## **AMENDMENTS TO THE DRAWINGS**

## REMARKS

Application No. 10/750,198  
Amendment Dated December 17, 2004  
Reply to Office Action of October 4, 2004  
Annotated Sheet Showing Changes

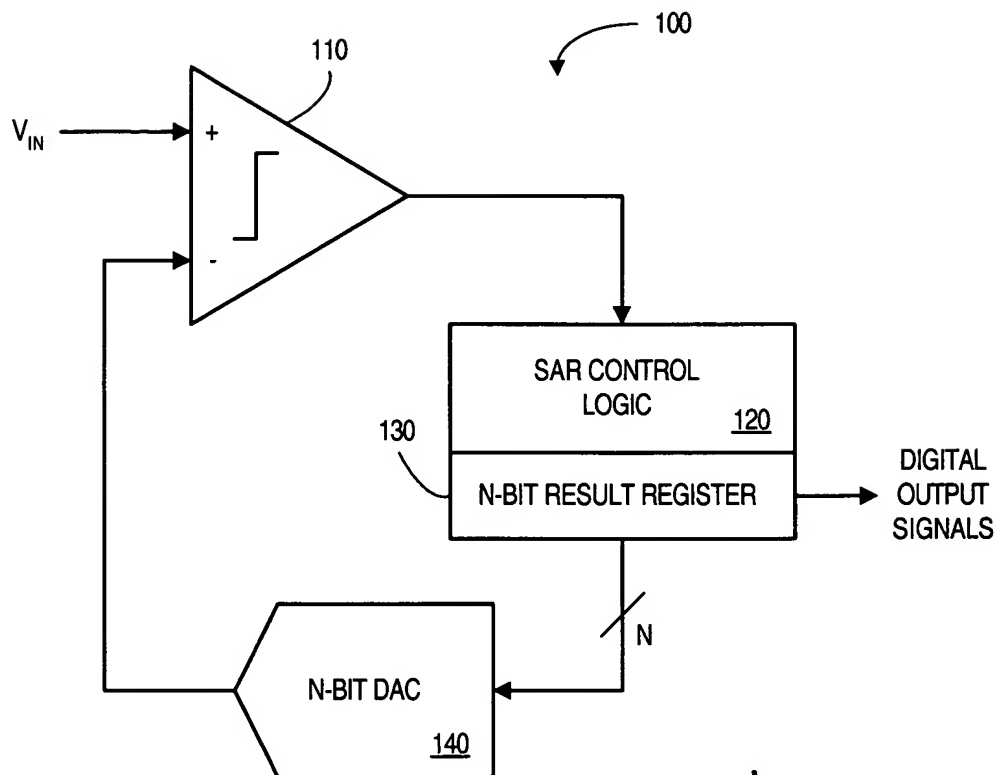
FIGS. 1 and 2 are objected to for lacking a "Prior Art" legend. The FIGS. have been amended as suggested by the Examiner.

add  
"PRIOR  
ART"

The attached replacement sheets of drawings includes changes to FIGS. 1 and 2. The replacement sheets replace the original sheets that included FIGS. 1 and 2. The replacement sheets add the words "PRIOR ART" to each FIG.
